STAFF RECOMMENDATION

1319 7th Avenue North
February 20, 2019

Application: New Construction—Outbuilding (Detached Accessory Dwelling Unit)

District: Germantown Historic Preservation Zoning Overlay

ELEVATIONS
A3

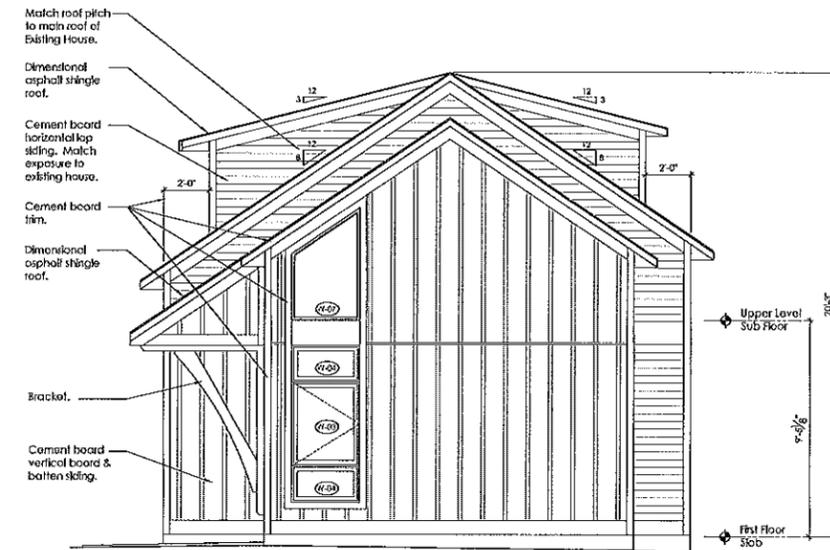
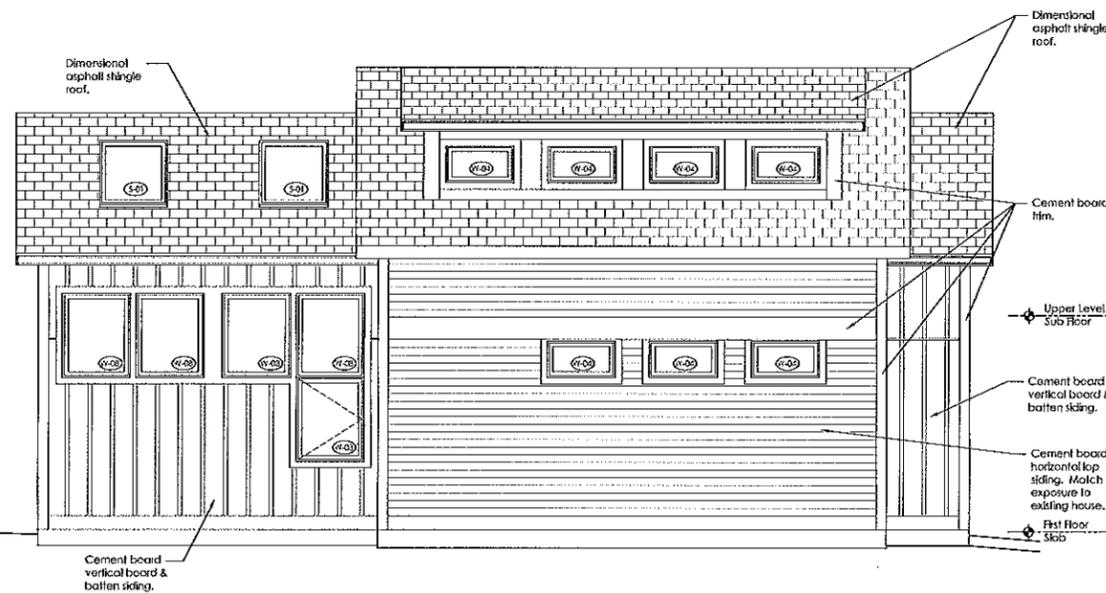
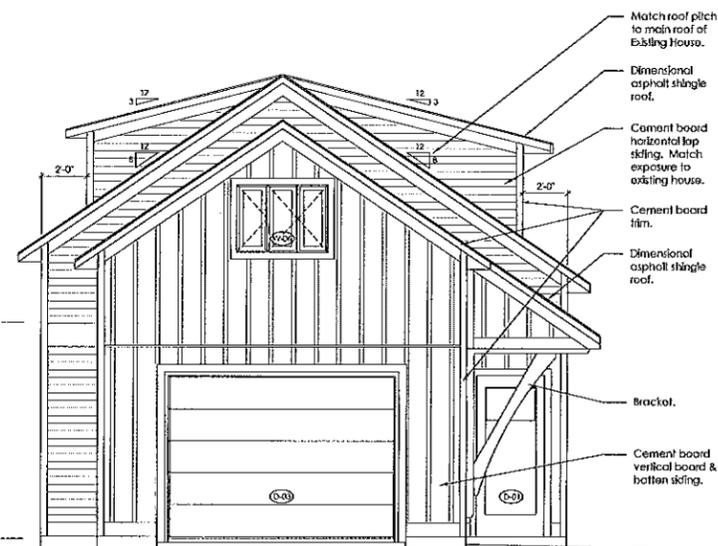
The twenty-foot three inch (20'-3") tall proposed DADU exceeds the height of the historic house by approximately two feet, nine inches (2'-9"), when measured as required by the italicized language in the design guidelines. Section IV.B.1.a of the design guidelines states that outbuildings should not exceed the height of the principal house. The design guidelines states that "the principle building should be measured from the floor line to the ridge of the main massing and the outbuilding from grade to ridge." Staff recommends that the overall height of the outbuilding when measured from grade not exceed the height of the house when measured from finished floor. This condition would satisfy the requirements of both the design guidelines and the ordinance.

The design guidelines and ordinance employ different standards to address the form of the outbuilding. The design guidelines state that "if the outbuilding has a second level, the knee wall of the second level shall not exceed 6'". As proposed, the outbuilding has a knee wall that is approximately one foot, four inches (1'-4"), which meets the design guidelines. The ordinance, on the other hand, uses eave height and the design of dormers to address form. Section 17.16.30.G.7.d of the ordinance states that "the detached accessory dwelling shall maintain a proportional mass, size, and height to ensure it is not taller than the principal structure on the lot. The detached accessory dwelling height shall not exceed the height of the principal structure as measured to the eave line, with a maximum eave height of ten feet for single-story and seventeen feet for two-story detached accessory dwellings." As proposed, the average eave height of the house is approximately eleven feet (11') whereas the average eave height of the DADU is eleven feet, nine inches (11'-9"). Not only does the eave height of the DADU exceed that of the house, but it also exceeds the maximum eave height of ten feet (10') since this is not considered a two story structure.

The proposed DADU meets the requirements of the ordinance for dormers as they do not exceed fifty percent (50%) of the roof plane and are setback two feet (2') from the exterior wall. While this requirement is not part of the Germantown design guidelines, staff finds that stepping the dormers in two feet (2') from the wall below helps the DADU read as more of a one and one-half story form instead of a full two stories, which is more appropriate behind a single-story house even with a slight change in grade.

Since the outbuilding meets the design guidelines with regard to the footprint and knee wall height, staff finds that the proposed height and scale could be appropriate and meet the Germantown design guidelines with the condition that the overall height of the

outbuilding when measured from grade not exceed the height of the house when measured from finished floor.

1. The overall height of the outbuilding when measured from grade shall not exceed the height of the house when measured from finished floor; and
2. Staff approve the final details, dimensions and materials for the roof color, windows, doors, garage door, and driveway.
